MEMO

SUBJECT: **Appeal of Subdivision Tentative Plan / Urban Growth Area Preliminary Declaration / Class 3 Site Plan Review / Class 2 Adjustment / Tree Regulation Variance / Class 1 Design Review Case No. SUB-UGA-SPR-ADJ-TRV-DR23-02 – 2100 Block of Doaks Ferry Rd NW; Open Rebuttal**

Attached are the comments received during the open rebuttal period ending on August 7, 2023 at 5:00 PM.

Attachment M – Polk County Survey CS13334 Segments

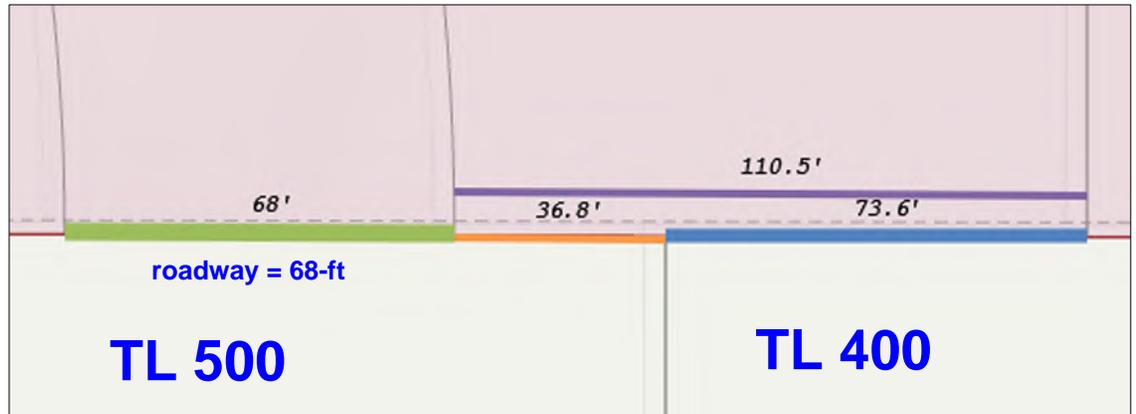
Please reconcile the distance between the DLC #66 NW corner and Tax Lot 400 NW corner before approving Titan Hill subdivision and development project.
